MATERIAL		DRAWN BY	Jack.Seeley	03/02/2020
THICKNESS		CUSTOMER	NEBRA (PI SUPPLY)	
www.smartboxx.co.uk		PART NO.	4520 (GA) -02	
		REV 02	SCALE: 1:1	SHEET 1 OF 1
				A4

DETAIL A

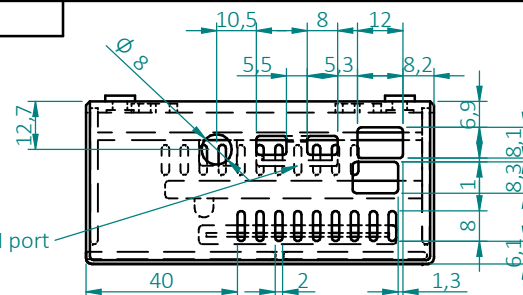
1.0 x 45° CHAMFER in the place of the 1.5mm Roundover to limit scratching.

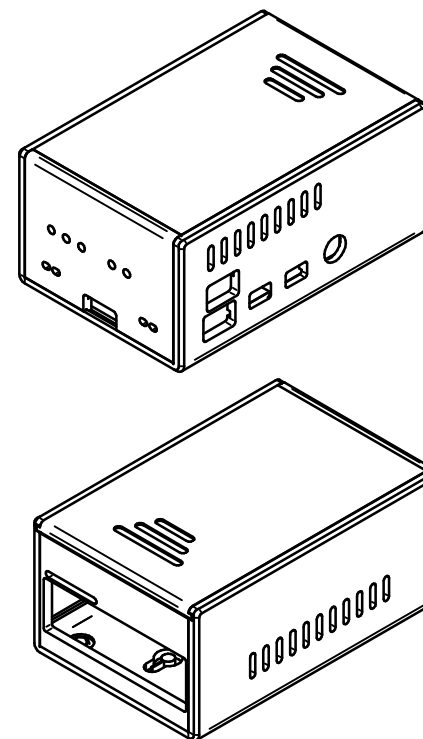
Front panel slot added to accomodate Pi 3 and Pi 4 in the end panel. This would decrease the strength of the panel so could look at bonding this to the base.
